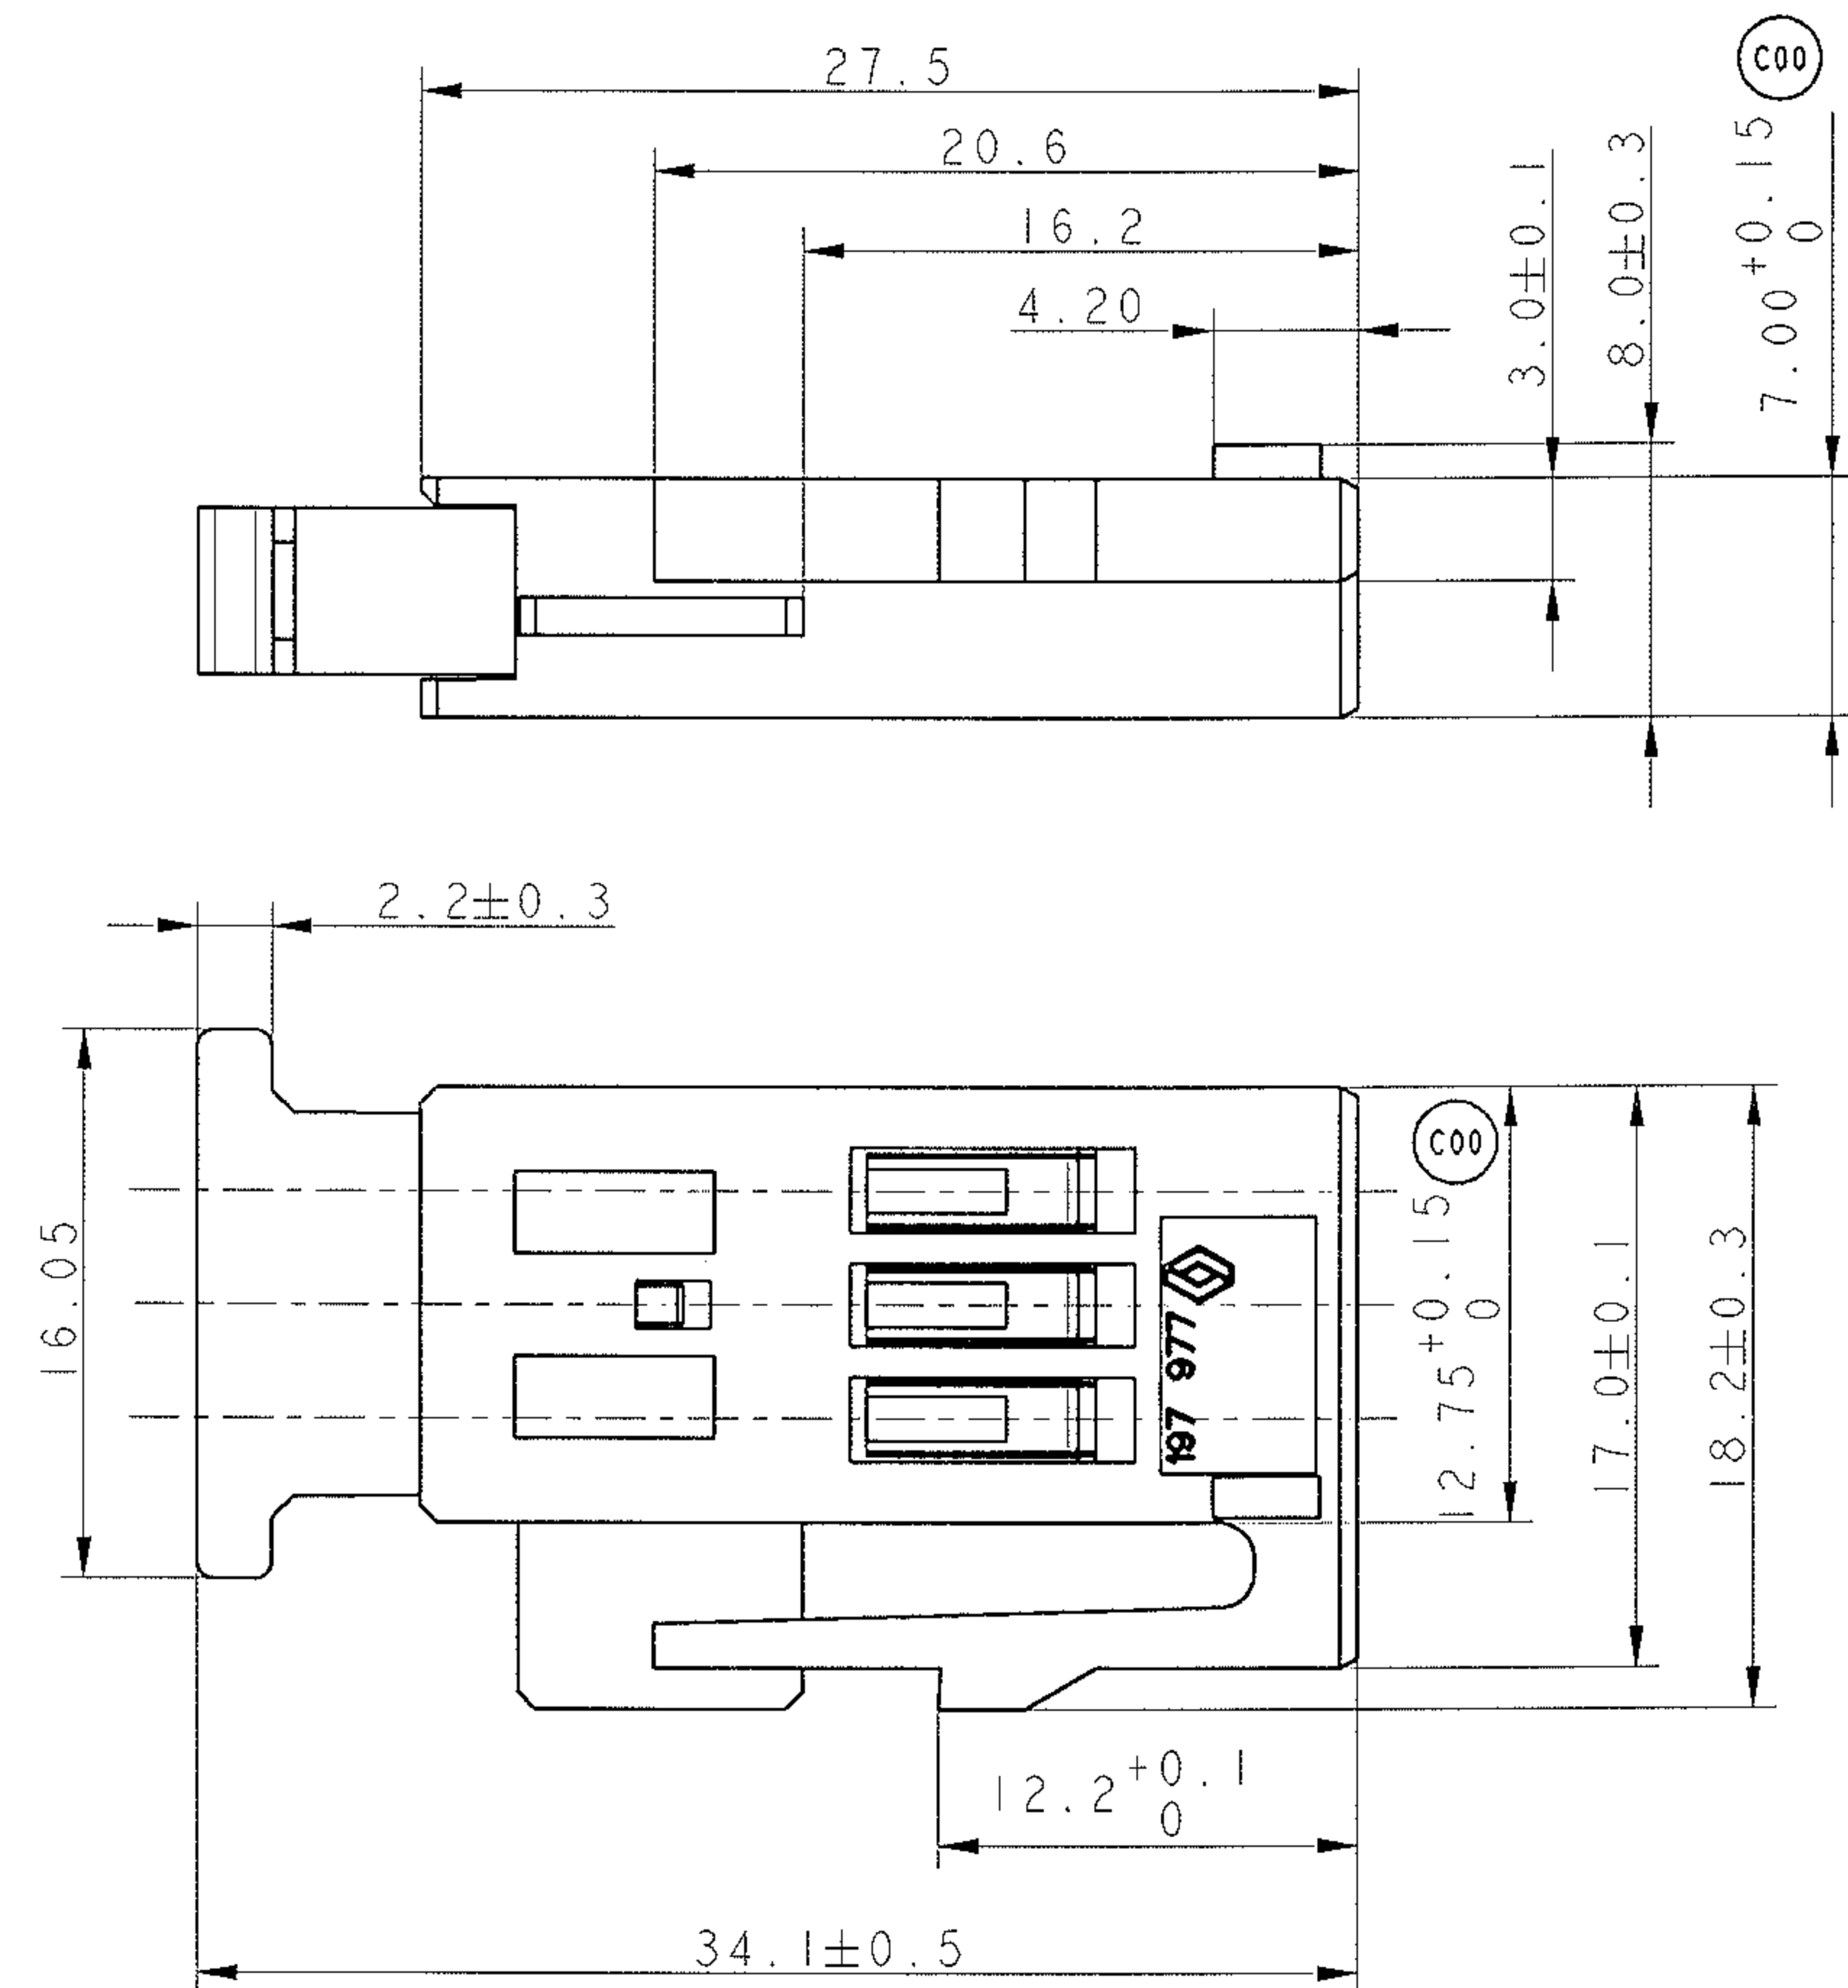
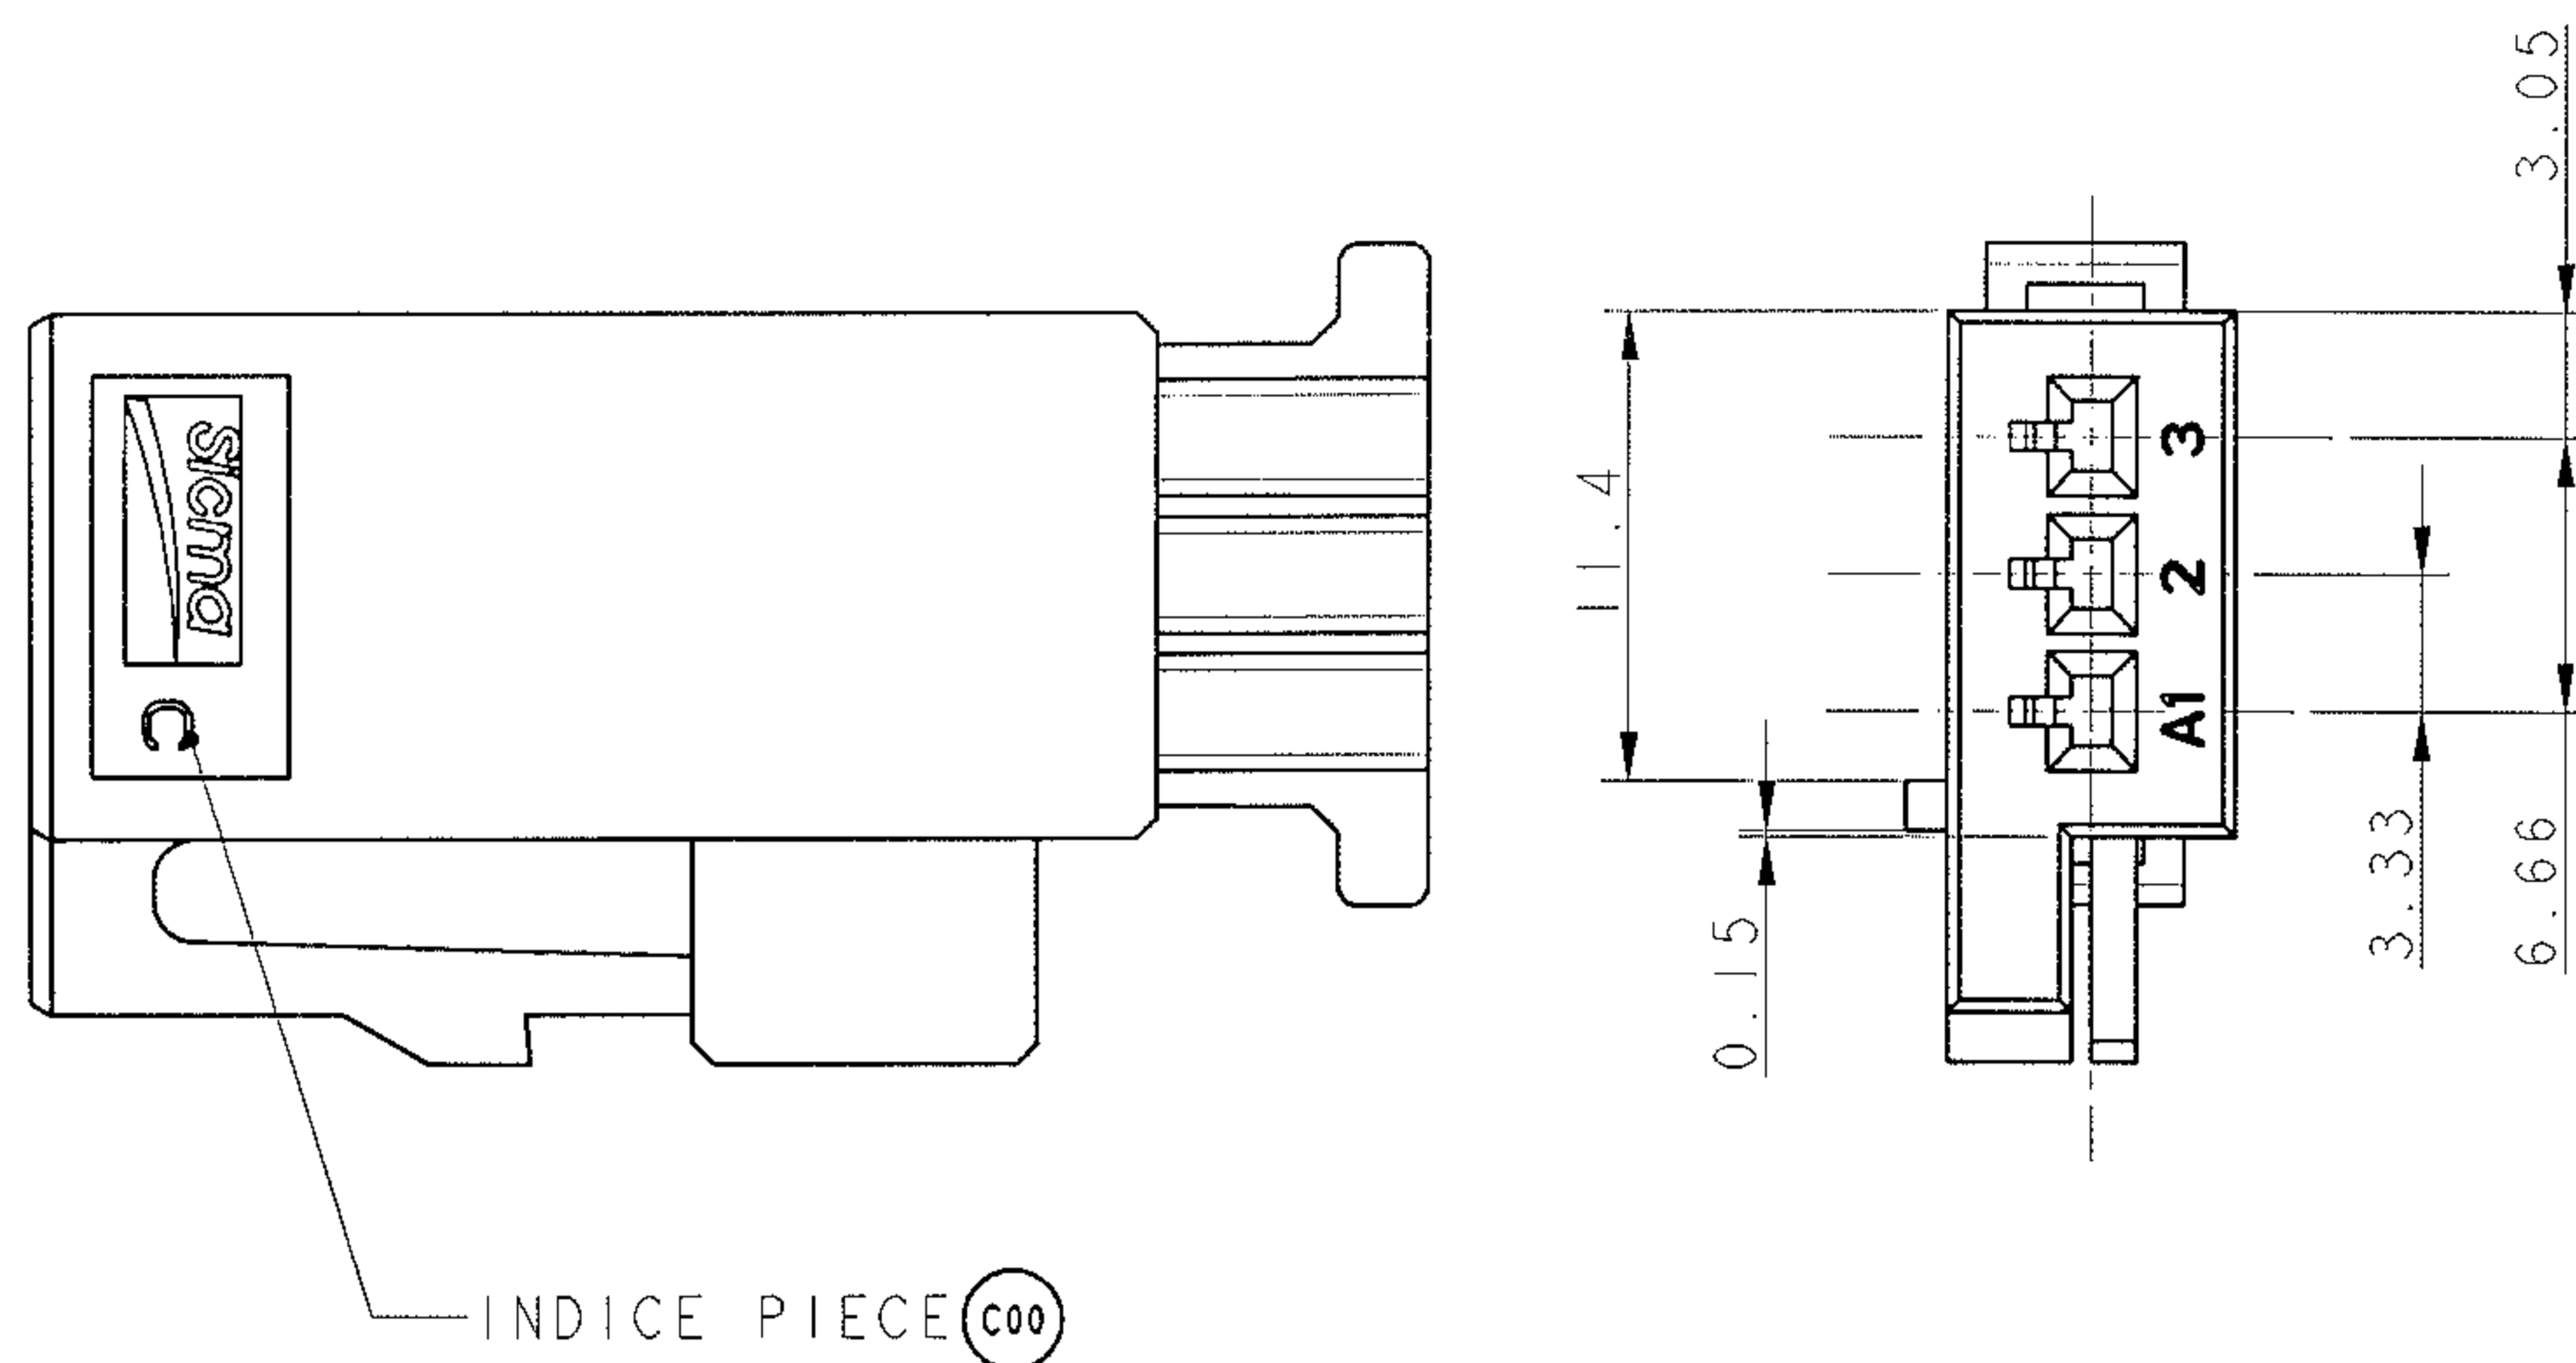
A 05 016		18/04/05		C00		- SEE DM 04-098 D4 2.2+0.3/-0.2 become 2.2±0.3 C7 ADD INDICE PIECE C3 12.75+0.10/-0.00 become 12.75+0.15/-0.00 C2 7.00+0.10/-0.00 become 7.00+0.15/-0.00		JD		 					
ECN-NO. NUMERO ECN		DATE DD / MM / YY DATE		REVISION INDICE		POSITION POSITION		CHANGE DESCRIPTION MODIFICATION		DRAWN BY DESSINE PAR		CHECKED BY VERIFIE PAR		APPROVED BY APPROUVE PAR	
PRODUCT SPEC. SPECIF. PRODUIT		PACKAGING SPEC. SPECIF. EMBALLAGE		APPLICATION SPEC. SPECIF. APPLICATION		THIS DRAWING AND ALL OTHER INFORMATION CONTAINED HEREIN IS PROPRIETARY AND THE PROPERTY OF FCI. This drawing may not be copied, reproduced or disclosed to any third party without the expressed written permission of FCI. © FCI April 1999		CE PLAN ET LES INFORMATIONS CONTENUES DANS CE PLAN SONT PROPRIETAIRES ET LA PROPRIETE DE FCI. Ce plan ne peut être copié, reproduit ou transmis sans l'autorisation expresse et écrite de FCI. © FCI Avril 1999
